PROJECT: 61 Acres @ 106 Grand Central Parkway

CITY OF LAS VEGAS				DATE:	
INTER-OFFICE MEMORANDUM				September 17, 2019	
TO: Land Development Services Department of Public Works				FROM: Jennifer Shinn, P.E.  Flood Control, Engr. Associate Department of Public Works	
SUBJECT: Drainage Study for: 61 Acres @ 100 Grand Central Parkway – Update (aka Symphony Park Access Road Extension)				COPIES TO: Lochsa Engineering	
Cross Streets:		Grand Central Parkway & Bonneville Avenue		City of Las Vegas Public Works Department	
File Number:		F:\Depot\DSMemos\DS3477D.doc		Bart Anderson, P.E., DevCo	
Parcel Number:		139-34-110-002 & 003			
Zoning Action:		N/A			
FEMA Flood Zone		YES		NO X	
Proposed Storm Drain		YES X		NO	
HISTORY	DATE RECEIVED	DATE REVIEWED	COMMENTS	REVIEW FEES	FEES PAID G.R. No.
1 st Submittal	1/6/2004	1/13/2004	Not Approved	\$400.00	117110: \$400
2 nd Submittal	4/20/2004	4/21/2004	Approved	N/C	-----
3 rd Submittal Paid on 11/26/2018	11/15/2018 & 11/26/2018	12/3/2018	See Comments Below	\$100.00	501171: \$100

**Technical Drainage Study
Update #2 to Update #4
For
61-Acres @
100 Grand Central Parkway
(Symphony Park Garages Parcel 'B')
(AKA: Union Park)**

Subject: **Symphony Park

EXHIBIT OF IMPROVEMENTS

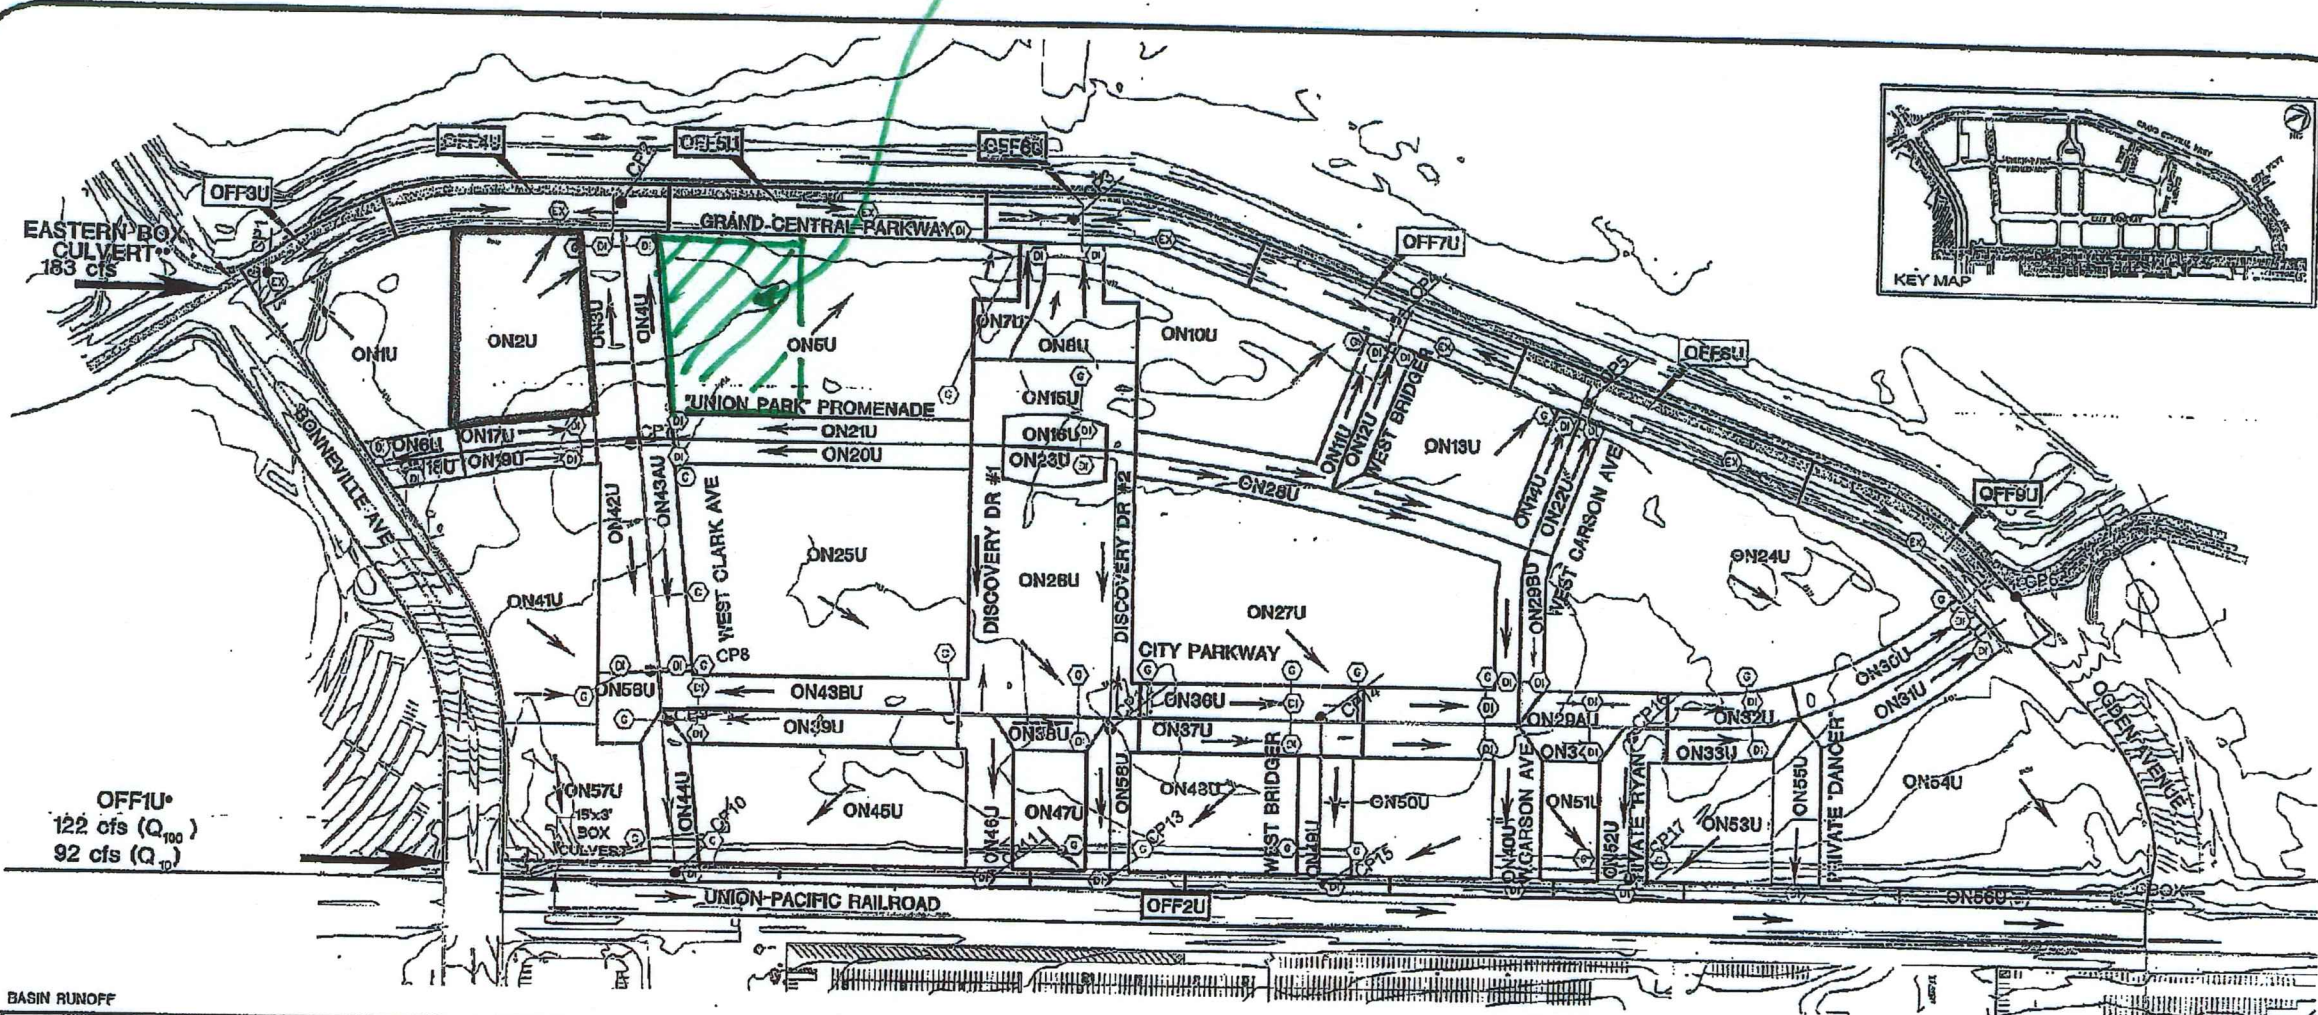
4th Submittal: Update to replace cross gutter with valley gutter and construct 9" 'A' Type Curb

9" curb to help
reduce cross-slope
to the proposed 3ft.
valley gutter
